DOCUMENT 00 90 03 – ADDENDUM No. 03

- A. Project Name: CAPITAL PROJECT PHASE 4.
- B. Owner: OWEGO APALACHIN CENTRAL SCHOOL DISTRICT.
- C. Architect: HIGHLAND ASSOCIATES.
- D. Construction Manager: TAMCO LLC
- E. Architect Project Number: 2024-240P.
- F. Date of Addendum: MAY 1, 2026.

- A. Issued herewith are the following Pre-Bid RFIs:
 - 1. Stark PB RFI 01
 - 2. Matco PB RFI 02
 - 3. SSD PB RFI 05

PRODUCT DRAWING
QTC3
WITH PUMP & HEAT RECOVERY
12 FAN
MATERIAL
ENG. STD.
PART NO.
COT SIZE
DRAWING NUMBER
035-28261-014
REVISION
01
SHEET 1 OF 1
Eng. Ckg

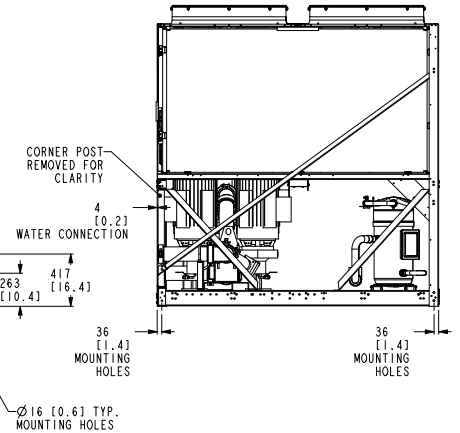
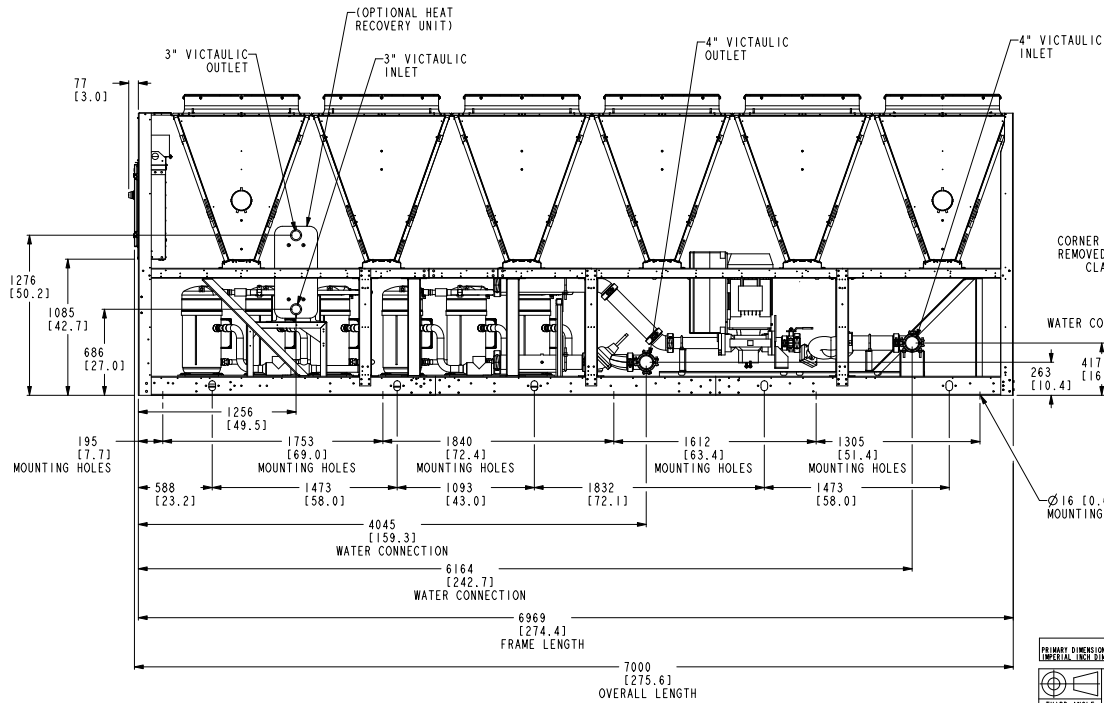
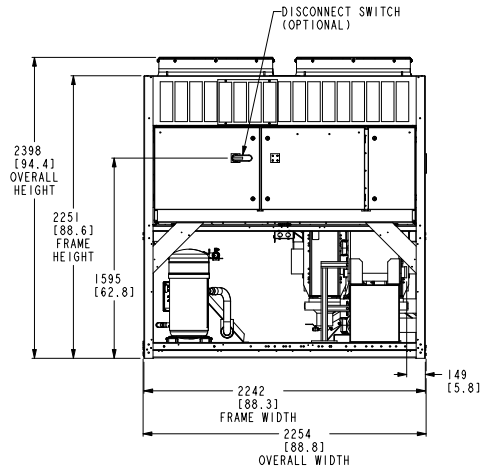
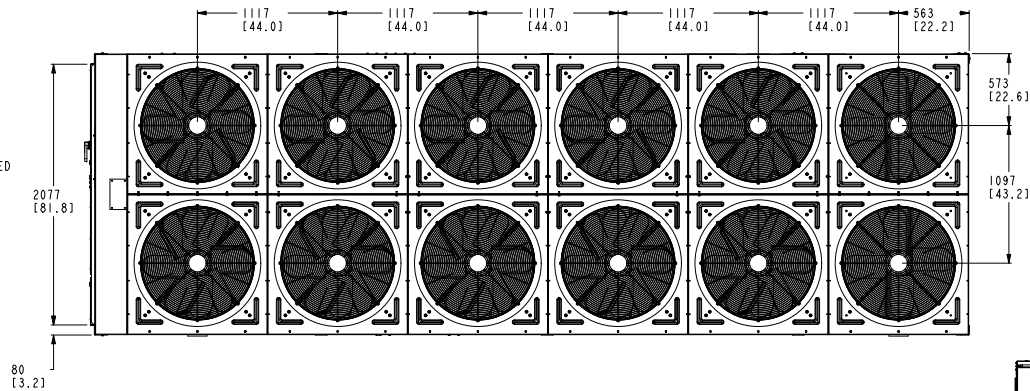
REQUEST: The schedule on M-601 calls out a 166T, 57-45F deltaT, 342 GPM
chiller. The chiller selection on M-505 calls out a 180T, 60-40F deltaT, 230 GPM
chiller. Please confirm the required chiller capacity and performance.

ANSWER: Provide the attached chiller package for CH-1.

PRELIMINARY FOUNDATION AND POLE ASSEMBLY DRAWING

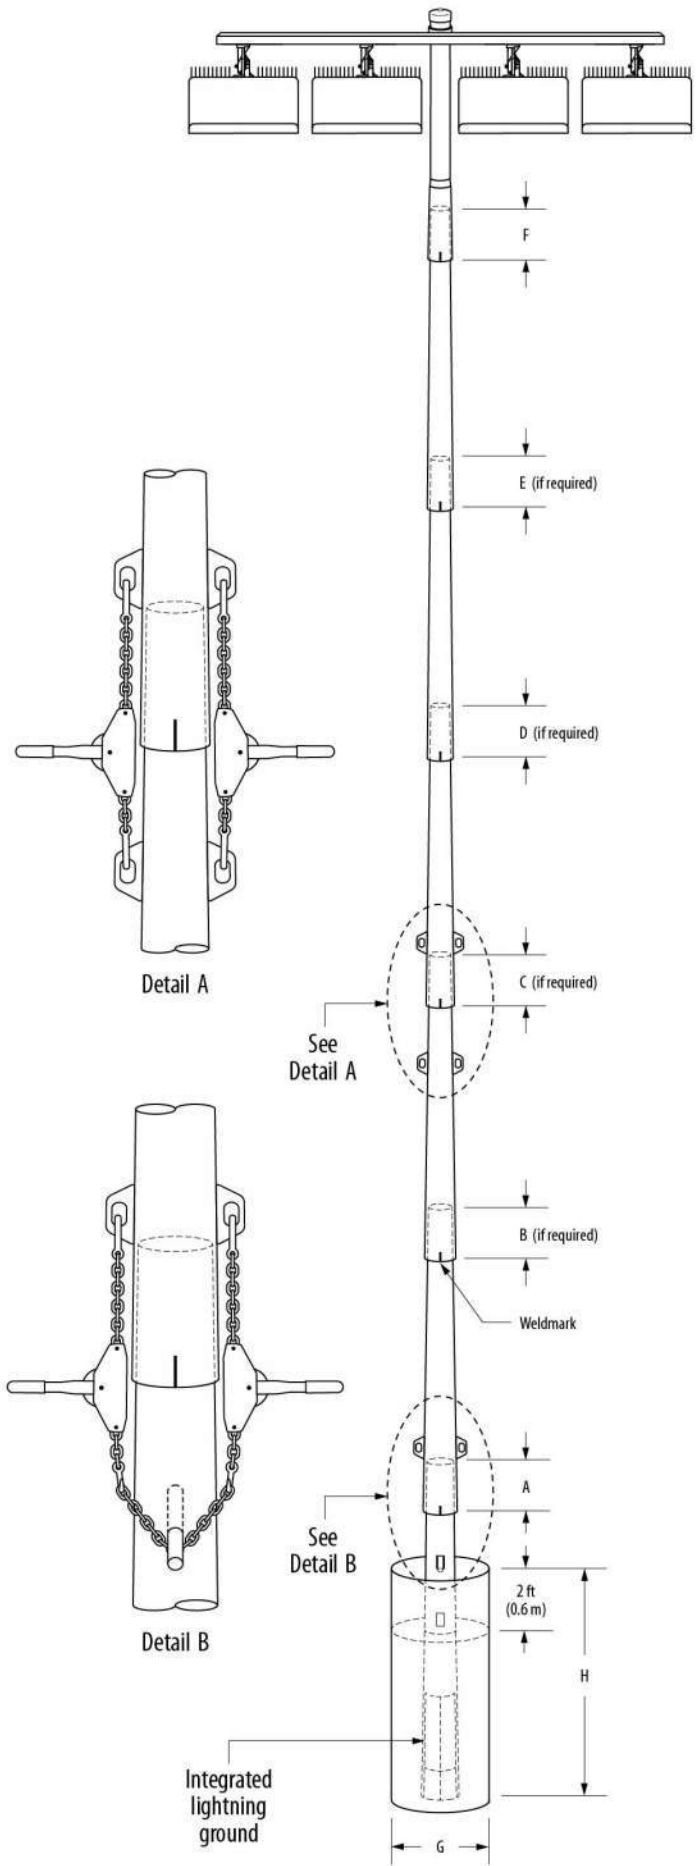
responsible for the concrete pole bases for the site lighting or the sports lighting in Alternate 03?

ANSWER: Could you please clarify this as the sports lighting typically has 17-20' deep foundations,

and I can't seem to find who is responsible for them. A detail with diameter and depth would

definitely help if the Sitework contractor is responsible for supplying sports field lighting
